UNITED STATES PATENT AND TRADEMARK OFFICE

APPLICATION NO.	FILING DATE	FIRST NAMED INVENTOR	ATTORNEY DOCKET NO.	CONFIRMATION NO.
10/509,434	06/06/2005	Tony Day	18133-213 NATL	7437

Office Action Summary

DETAILED ACTION

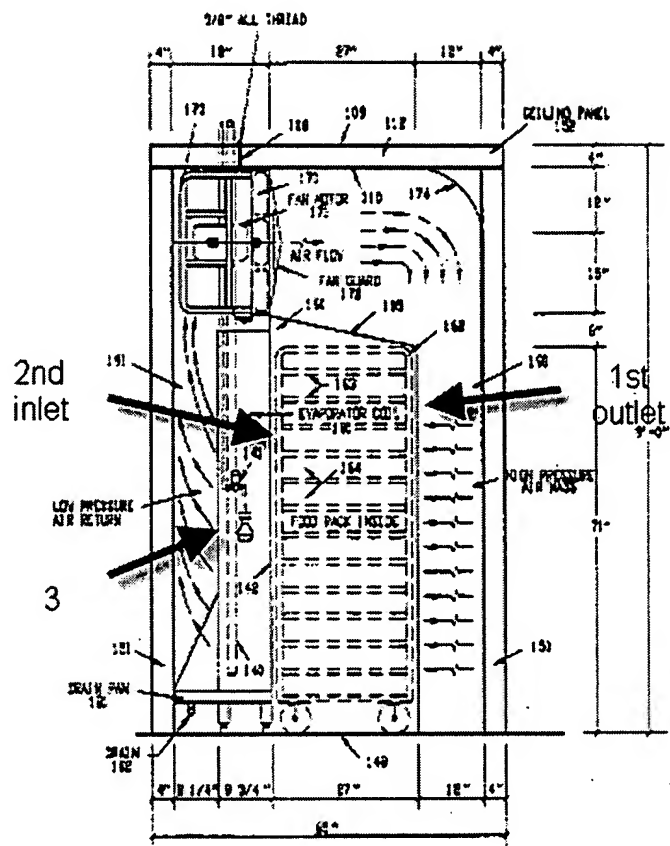
15. Claims 76-78 are rejected under 35 U.S.C. 103(a) as being unpatentable over Ledbetter 5,826,432 in view of Fujimoto 5,952,842 and further in view Applicant's admitted Prior art figure 1.

Ledbetter in view of Fujimoto teaches an invention as discussed above but is silent about an outer enclosure with external panels around the cabinet, an air conditioner between the cabinet and outer enclosure.

Applicant's admitted prior art (fig. 1) teaches the outer enclosure 4, 3, 5 with external panel 7 and 2, and air conditioner 16 between outer enclosure and the cabinet.

It would have been obvious to one of ordinary skill in the art to have the Ledbetter in view of Fujimoto apparatus within Applicant's admitted prior art enclosure and air conditioner in order to provide ventilation of the equipment inside the cabinet (spec. page 6, ll. 13-34 through page 8, ll.1-27).

(fig. 4 of Ledbetter)

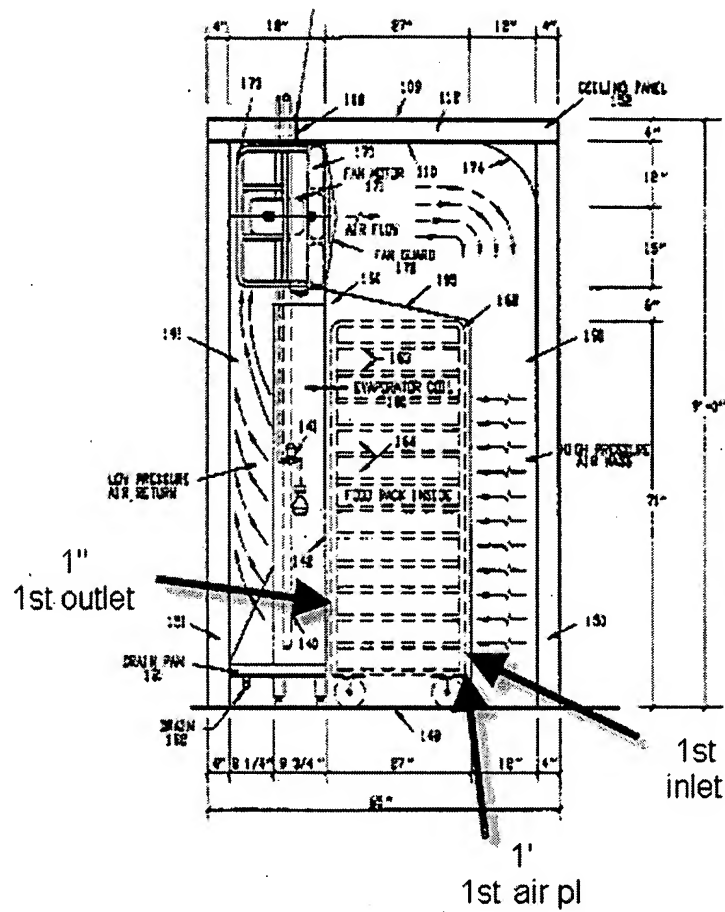
Ledbetter teaches an invention as claimed: a substantially sealed airtight cabinet (fig. 4) sized for housing vertical array of heat-producing units 162 having an exterior shell 109, 190, 151, an interior divider wall 160 disposed inside the cabinet wherein the shell and the divider wall provide an equipment chamber 164, 163, with a first plenum 190

and a first inlet 172 defined by the divider as an at least one substantially vertical slot, admitting the air uniformly over a substantial vertical length (fig. 4); a first outlet 1 (see paragraph 16 bellow of this Office Action, wherein examiner marked originally not marked first outlet 1 with darkened arrow for clarification) wherein the first plenum communicates with the openings for exhausting substantially all of the flow through the array in substantially horizontal direction (fig. 4); a second plenum 191 defined between the chamber shell and the array for receiving the air that has passed through the array having a second inlet 2 (see paragraph 16 bellow of this Office Action, wherein examiner marked originally not marked second inlet 2 with darkened arrow for clarification) and second outlet 3 (see paragraph 16 bellow of this Office Action wherein examiner marked originally not marked second outlet 3 with darkened arrow for clarification) defined by the divider wall such that the air is directed horizontally (fig. 4) from equipment chamber 164,163; a heat transfer means 180 (col. 6, ll. 21-25) disposed in the cabinet for carrying heat away from the cabinet; a door 210 (fig. 7) configured to provide selective access to the heat-producing units based on at least one of an environmental compatibility inside and outside the cabinet (fig. 11A), when the enclosure around the cabinet is closed (col. 9. ll. 47-63) wherein the doors have independent locks (fig. 11A).

on the consideration of the first inlet, first air plenum and first air outlet as shown in paragraph 16 of this Office Action. First inlet 1 described as first outlet in discussion above, with first air plenum 1' and first outlet 1" wherein the first inlet extends substantially a full vertical extent of at least one of the array and the first plenum.

16. Examiner marked originally unmarked elements with darkened arrows for clarification.
